VI. Addendum A: Response to Stewart Environmental

USR-15-0027

Re: Response to Stewart Environmental Consultants LLC comments regarding the Air Emissions Report Analysis that was submitted to the Weld County Commissioners on June 18, 2015.

Response to Stewart Environmental Consultants LLC comments regarding the Air Emissions Report Analysis

Figure 1. Slide from D. Hagerman's presentation at Public Meeting, June 9. 2015

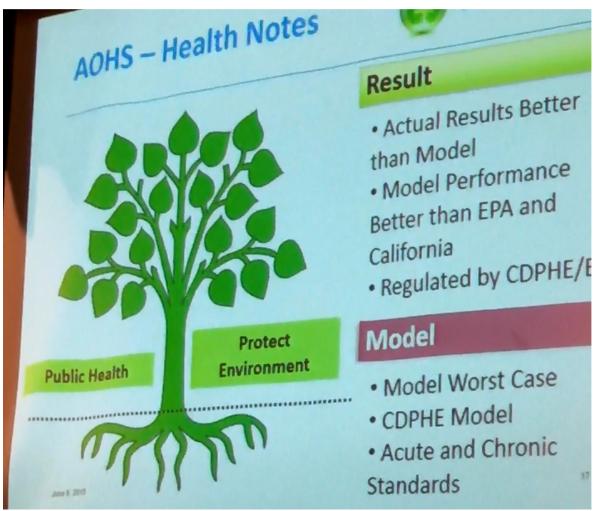
The entirety of his comments can be reviewed here: https://youtu.be/AzYLnehHmZo Furthermore, Figure 1 shows one of the slides that he used during that presentation, emphasizing their claim that they do the modeling with the worst case scenario.

- allow the estimation of the pollutant concentrations at the property line as well as nearby "sensitive receptors".
- b. The use of the MAXIMUM possible hourly production is clearly claimed by Mr. Hagerman to be the procedure that was used. However, we found that this was not the case. When we reported this fact, Stewart responded by asserting that it's not appropriate. Apparently, Mr. Hagerman does not agree!!

- d. At the Planning Commission meeting, we also pointed out that the estimated level of formaldehyde exposure does, in fact, far exceed the more stringent limit of $9\,\mu\text{g/m}^3$. Referring back to Figure 1, although Mr. Hagerman apparently was happy to compare the AERSCREEN results to the California standards, at the Hearing Mr. Stewart devalued that comparison by saying that the CA limit was irrelevant because it was California. Again, you can't have it both ways. Eliminating the CA comparison because you don't like the results when the estimate is done correctly is not only invalid, but it also suggests that the entire approach to analyzing the emissions is not based on an honest assessment, but rather on a desired outcome.
